RE: Urban design review of Planning Proposal for 79-81 Queens Road and 2-12 Spencer Street, Five Dock

Please find below a high level Urban Design Review of a Planning Proposal for 79-81 Queens Road and 2-12 Spencer Street, Five Dock

Figure 1, DCP and Planning Proposal plans (by Projected Design Management) with ADG setbacks for habitable uses overlaid by SGL

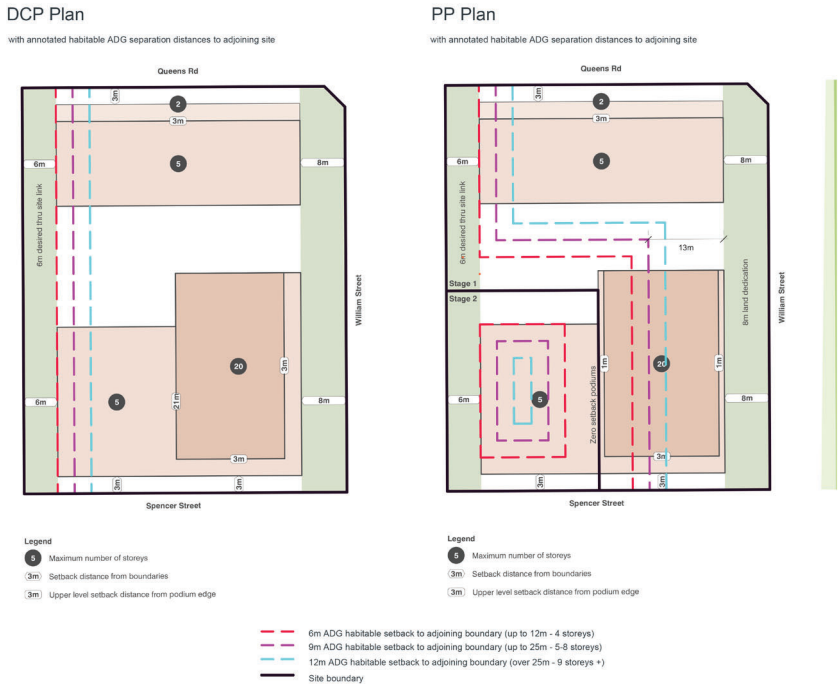
The Indicative Design Concept shown in the Planning Proposal uses a built form identified in the DCP which was created assuming ADG setbacks for an amalgamated site not for two separate sites. The plans refer to development on 10-12 Spencer Street as Stage 2 however there is no evidence provided in the Planning Proposal that there is agreement from the owner of this site to Stage 2 or to this Planning Proposal and therefore it must be treated as a future development on a separate site.

The western wall of the proposed tower shown in the Indicative Design Concept is less than 3m from the boundary with 10-12 Spencer Street and therefore habitable or non-habitable uses cannot be located along this side elevation. This would also mean that this long wall of the proposed tower would provide limited outlook, natural ventilation and daylight access and amenity.

In addition, to meet the requirements of the National Construction Code the majority of this side of the 20-storey tower could not have windows or openings facing the boundary and therefore the western elevation would be predominantly blank.

A potential building envelope that considers the ADG setbacks has been developed and tested by SGL. To achieve an appropriate urban form with a reasonable level of amenity it is recommended that development is setback from shared boundaries by 6m where possible, however if the uses facing this boundary are non-habitable this setback may be able to be reduced to 3m.

Figure 7 Planning Proposal Plan

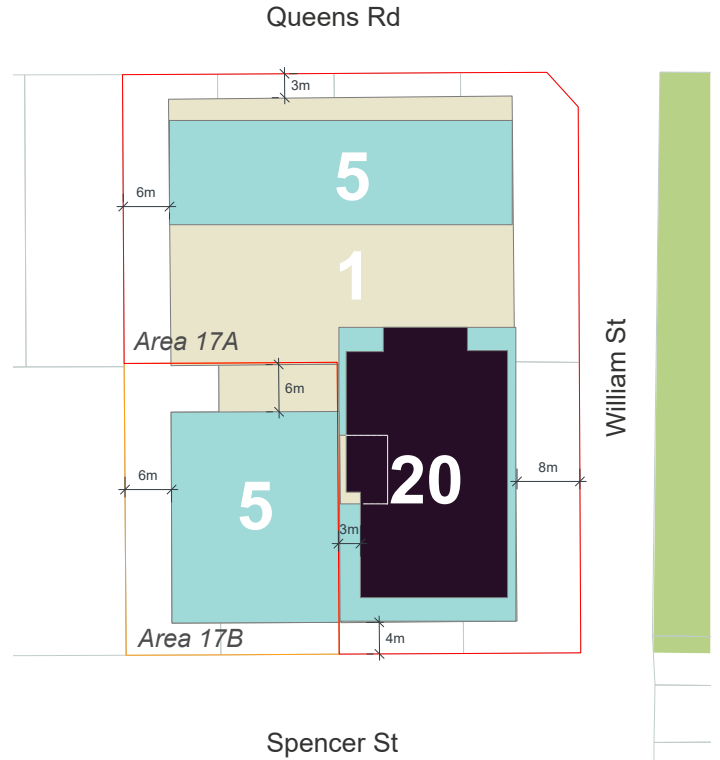
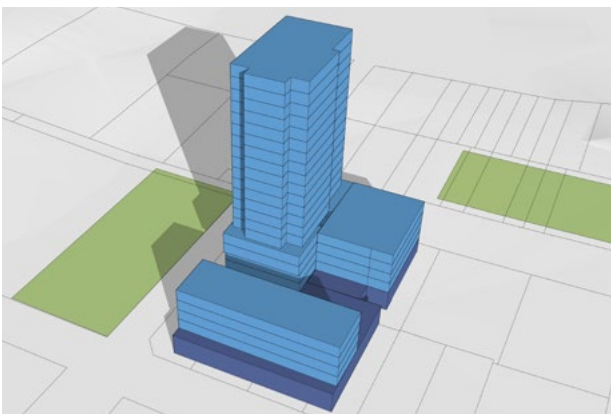
The Indicative Design Concept for 79-81 Queens Road and 2-8 Spencer Street shows an arch shaped cutout along the western boundary of the site for up to five storeys. This cutout creates a very poor design outcome as it will be almost fully enclosed on all sides once 10-12 Spencer Street is developed and it is also almost fully covered by the Lower Tower located above. The Indicative Design Concept implies that apartments to the north and south of this cutout will be cross ventilated but it is difficult to see how this will occur.

The Indicative Design Concept for 79-81 Queens Road and 2-8 Spencer Street has also relocated the tower closer to William Street and the Urban Design Analysis states that “This independent urban design analysis has concluded that the difference in the visual impact between a 3m and 1m setback above podium is negligible for the scale of a 20-storey tower or more” and *“The alternative 1m setback has a similar visual impact as the CBDCP envelope, and it achieves a similar contextual fit with the evolving surrounding context. The built form testing has also demonstrated that the pattern of overshadowing has similar, if not less, impacts than that of the envelope predicated by the Kings Bay Precinct Master Plan.”*

The area schedules submitted with the Indicative Design Concept include figures that show the proposed concept on 79-81 Queens Road and 2-8 Spencer Street achieves a FSR of 3.15:1. The area figures show that above the 14 storey (Level 13) a reduced floor area that is about one third smaller than the levels below. This reduction in floor area is not shown in the 3D model or sections and floor plans for levels above the Level 13 are not provided. Increased setbacks and/or reduced upper levels are not a requirement of the City of Canada Bay LEP or DCP and so it is assumed that this is an error. When the total floor area shown in the Indicative Design Concept 3D model is included in the calculations the Indicative Design Concept currently achieves a FSR of approximately 3.7:1.

It would be preferable that the setback remain at 3m and independent testing by SGL has indicated that a reduction in this setback is not required to achieve the maximum bonus FSR.

It is therefore recommended that if the two sites are split, and the overall FSR for both sites within Area 17 remains at 3:1, the maximum building envelopes for the tower and possibly the Queens Road podium of 79-81 Queens Road and 2-8 Spencer Street are lowered in height and/or have smaller ground floor footprints to ensure the required landscape and deep soils areas can be delivered, and the overshadowing of William Street Park is minimised.

Figure 8 South-western View: SGL Potential Alternate

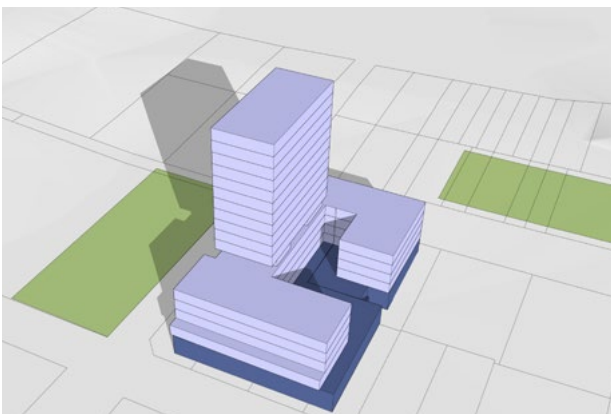
The potential building envelope also seeks to minimise the extent of blank façade on the western elevation of the tower by locating the tower further away from Spencer Street and towards the centre of the site. The design tested would allow approximately half of the western façade to be habitable with the remainder if the tower at least 3m off the boundary, allowing for some windows and articulation to the built form. This potential building envelope would increase overshadowing of the William Street Park, but the overshadowing impacts could be minimised by the architects during detailed design.

SGL's independent testing of a potential 5 storey building envelope on 10-12 Spencer Street show this site could achieve a FSR of 1.8:1. The SGL testing also shows that, by separating the sites, reducing the FSR on 10-12 Spencer Street and maximising development with the building envelopes, a much higher FSR is occurring on 79-81 Queens Road and 2-8 Spencer Street. For example, using the current maximum building envelopes, the Indicative Design Concept is achieving a FSR of around 3.7:1. SGL's independent testing of a potential building envelope at 79-81 Queens Road and 2-8 Spencer Street show that development with a 5 storey podium, but with a lower 17 storey tower, would achieve a FSR of 3.3:1.

- ▶ A potential building envelope that considers the impact of ADG setbacks has been tested by SGL This testing suggests that the larger site, Area 17A which is 3,151m² should be able to accommodate a development with a FSR of 3.3:1 and Area 17B which is 962m² should be able to accommodate a development with a FSR of 1.8:1. The two sites combined would then have a FSR of 3:1.

- ▶ Both the Indicative Design Concept and the SGL testing show that a twenty-storey building is not needed to achieve the maximum FSR on Area 17A. This means the building could be lower in height (approximately 17 storeys) and/or have a lower podium along Queens Road and smaller ground floor footprint to minimise overshadowing and ensure landscape and deep soils areas can be delivered.
